April 16, 2014

**Subject: Cochrane Solar Project – Project Design Change
Amendment Application – Renewable Energy Approval # 1290-9A4KSE**

H334844-0000-90-218-0232, Rev. 0

Figure 1.1
 Northland Power Inc.
 Empire Solar Project
Water Body Features
Solar Panel Project Location

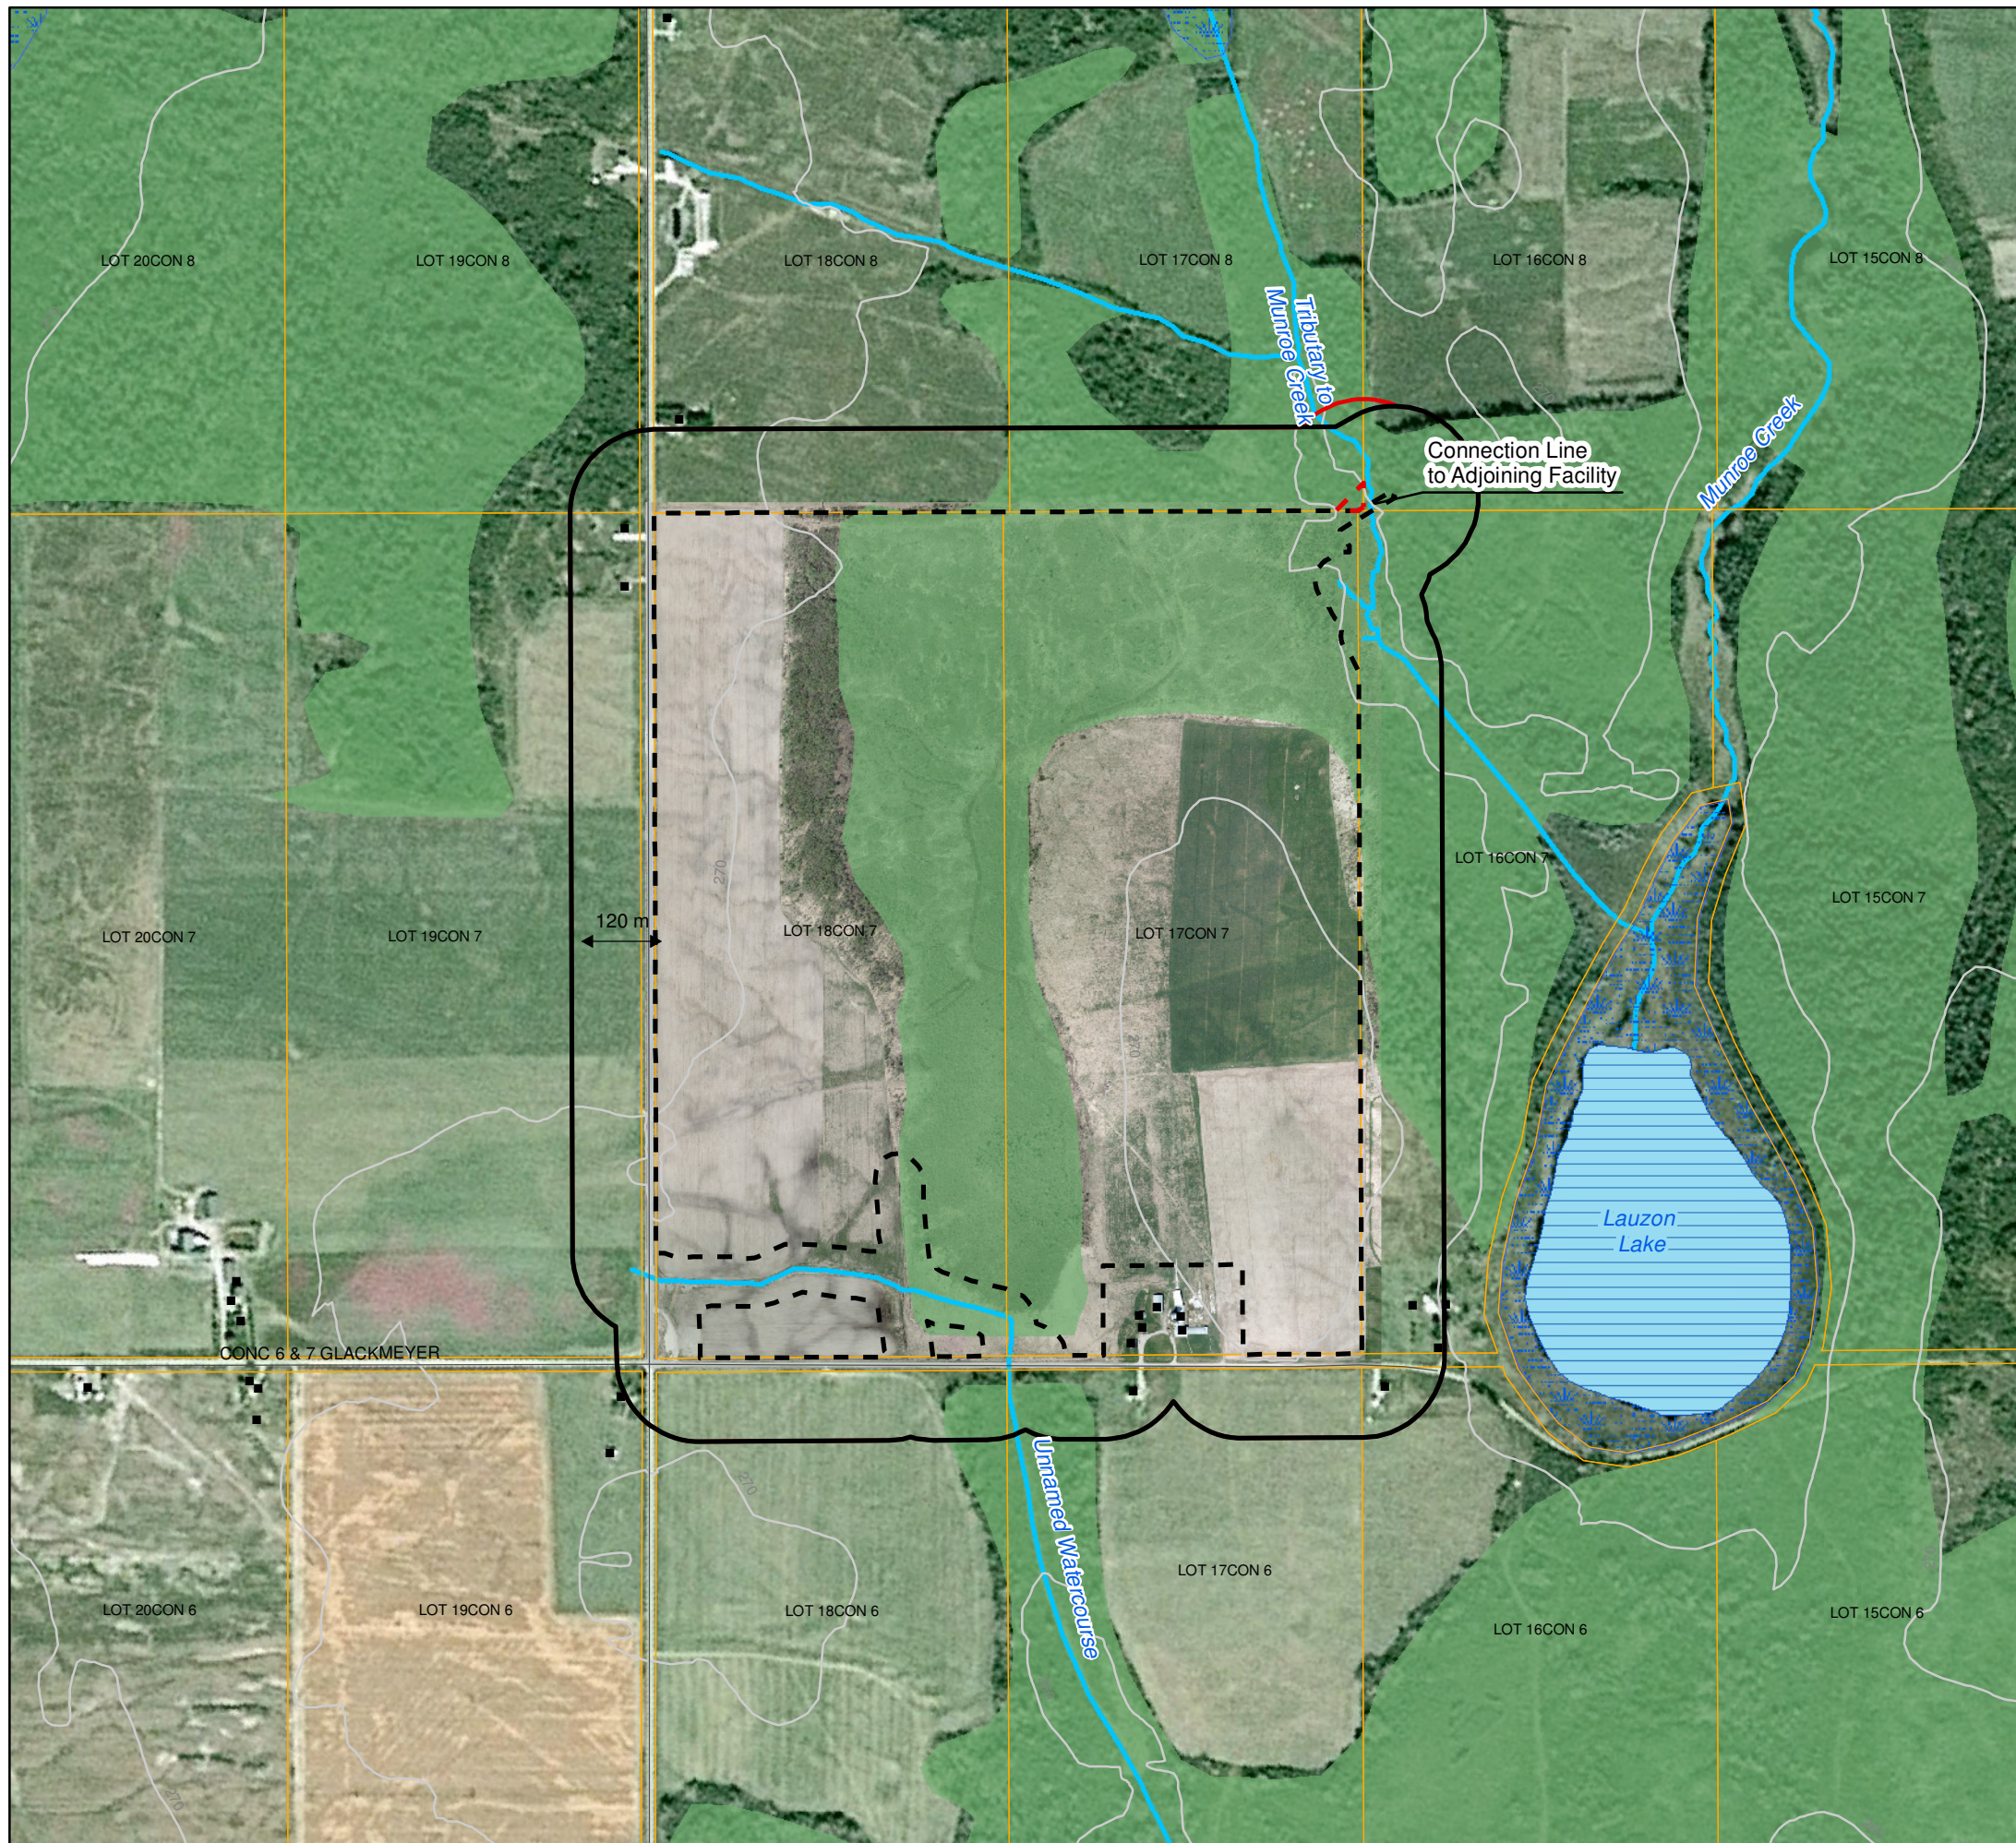
Page	Section	Original Text	Revised Text
5	Figure 1.1	Figure	Revised Figure 1.1 (Attachment C of this report)

Figure 1.1
 Northland Power Inc.
Empire Solar Project
Water Body
Site Investigation Results

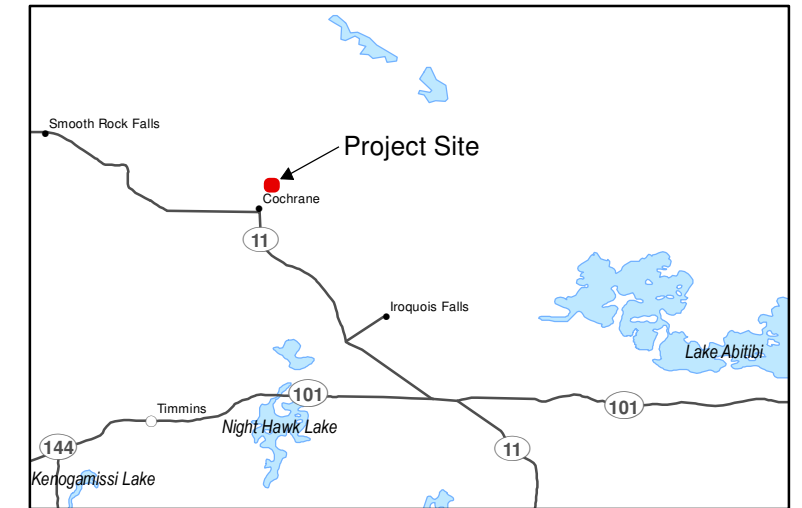
Page	Section	Original Text	Revised Text
5	Figure 1.1	Figure	Revised Figure 1.1 (Attachment D of this report)

Page	Section	Original Text	Revised Text
5	Figure 1.1	Figure	Revised Figure 1.1 (Attachment D of this report)
26	4.2.1.5	n/a	<p>The connection line to the adjacent facility will cross the Tributary of Munroe Creek using horizontal directional drilling. Mitigation measures to reduce the potential for sediment and erosion release includes the following:</p> <ul style="list-style-type: none"> • Installation to a depth of at least 1 m below the watercourse bed to prevent the conduit from becoming exposed due to natural scour of the bed • Bell holes will be installed outside the high water mark of the watercourse. • Installation of sediment and erosion controls including silt fencing on the downstream side of each bell hole excavation. Erosion and sediment controls will be regularly monitored throughout the construction period to ensure continued effectiveness with all necessary repairs made as soon as possible. • In the case of high-pressure drilling, a containment system consisting of a berm, a minimum of 0.30 m high will be installed around the boring equipment, boring fluid mixing system, entry and exit pits and the boring fluid recycling system (if utilized) to contain any accidental spills of boring fluid. • No machinery fording of the watercourse will be required. • Machinery will arrive on site in a clean condition and will be maintained throughout the construction period to ensure that it is free of leaks. • Machinery will be washed, refueled and serviced at designated locations on the Project site away from watercourses and wetlands. • An emergency spill kit will be present on-site at all times. • If dewatering of bell holes is required during installation, the water will be pumped to a heavily vegetated area or sediment bag to prevent sedimentation in the watercourse. • All soil excavated from bell holes and the bore hole will be stockpiled at least 30-m from watercourses and stabilized appropriately to prevent erosion and sedimentation. • After backfilling of bell holes is complete, all disturbed areas will be revegetated with an appropriate seed mix.

Figure 1.1
 Northland Power Inc.
Empire Solar Project
Solar Panel Project Location and Evaluation of Significance

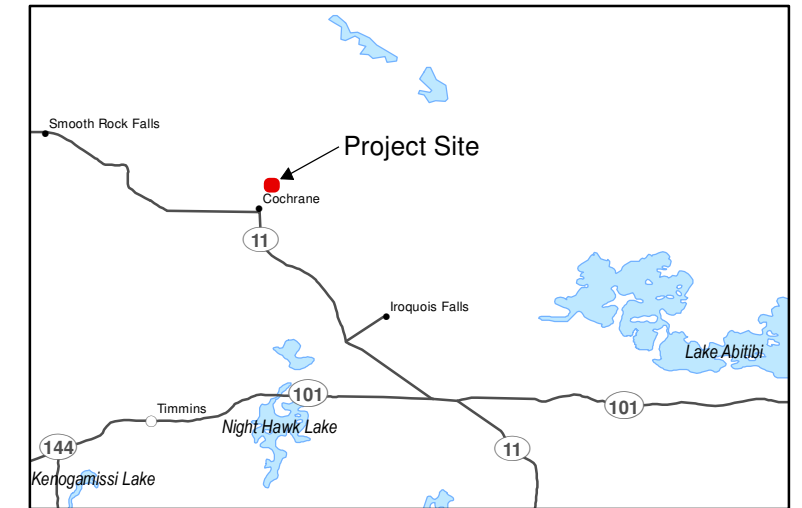
An additional 0.08 ha of land (in a triangular shape) has been added to the Project at the corner connecting the Empire and Martin's Meadows properties (as shown in the figure provided in Attachment A) in order to accommodate the installation of the 27.6-kV connection line at this location. Originally it was intended to have the connection line pass directly over the abutting "kitty corners" of the two properties. Upon review of the electrical code, it was determined that connection line must be over land controlled by the proponent and the line cannot cut across two corners, but must have land rights on either side of the wire.

Though additional lands are required for the Project, the location in question was considered during the site visits associated with the project developments and no new natural features are identified in or within 120 m of this location. Though an additional 0.08 ha of the provincially significant wetland will be lost in association with the proposed development, this will bring the total amount of removal required up to 46.3 ha from the 46.2 ha originally proposed, which is considered to be an insignificant increase in the amount of wetland removal proposed. As a result, no new mitigation measures are proposed with respect to this additional removal, and therefore no material changes to the Natural Heritage reports is considered to be required beyond the provision of updated mapping as shown in the figure provided in Attachment A.
